CONSERVATION TEAM CONSULTATION APPLICATION RESPONSE

APPLICATION REF:	26/00229/FP
CASE OFFICER:	HT
APPLICATION SITE:	St Marys Church Hall, Church Street, Baldock Hertfordshire SG7 5AE
DESCRIPTION OF WORKS:	Single storey front extension. Roof extension over existing front entrance and new glazed doors and window screen in forward position, installation of 3 rooflights to existing rear roof slope, replace existing dormer windows on front slope with rooflights and alterations to existing fenestration, including retention of two windows on existing side elevation. Installation of solar panels to existing front roof slope, and installation of an air source heat pump onto each side elevation. Access ramp to new fire exit door on side elevation following bricking up of existing fire exit. Formation of a disabled/maintenance parking space and landscaping.

Single storey front extension.

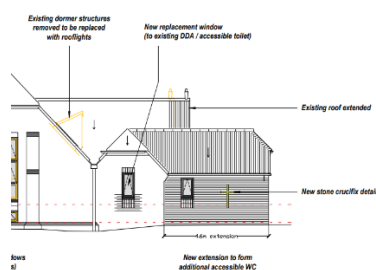
I have a few minor observations, the first being that it is slightly unfortunate that barge board to the gable of the existing gable entrance is truncated to facilitate connection with the extension. Having said that, the gable remains almost intact. Next and perhaps a more valid point, I question the location of the window to the 'front' WC. I would have thought it better to place a window on the south-west elevation i.e. where the stone crucifix detail is proposed and to move the stone crucifix onto the front elevation thereby denoting the entrance to the hall. Otherwise, this aspect of the scheme is acceptable as no harm would be occasioned to heritage assets.

Installation of 3 rooflights to existing rear roof slope.

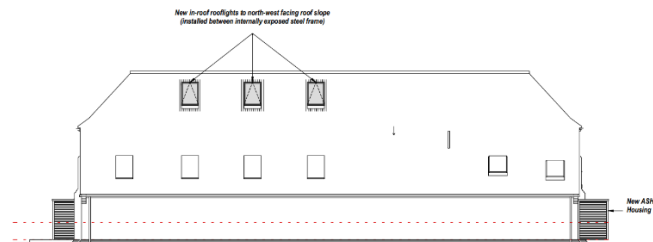
The reason given for this is 'to increase natural light and improve ventilation'. My slight concern is that their size and position (high up in the roof plane) will mean these are more prominent when viewed from properties directly to the north (albeit these would not be public viewpoints). I would encourage smaller roof lights positioned slightly further down the roof if that can be achieved.

Installation of solar panels to existing front roof slope, and installation of an air source heat pump onto each side elevation.

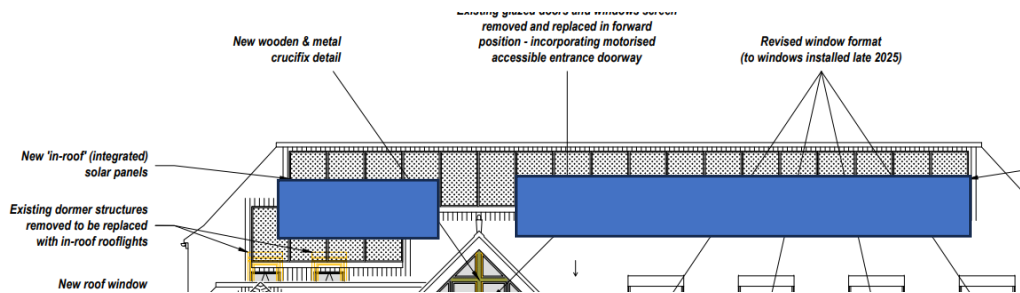
There is a case to suggest that the array of solar panels will have a detracting impact upon the hall building and the setting to St Marey's Church. The panels are positioned high up on the front roof slope. I am not opposed to some solar panels particularly considering that paragraph 4 of HE6 of the NPPF states (my emphasis in red)

Due to their position on the roof, they would be very close to the ridge. Also, is there sufficient distance between the top of the new rooflights and the bottom of the lower solar panels to ensure a good weathering detail? In my opinion, the impact can be ameliorated if the number of panels was reduced and the continuous coverage separated as indicated below in blue which would still achieve a 16-panel scheme (a reduction of 6no. panels).
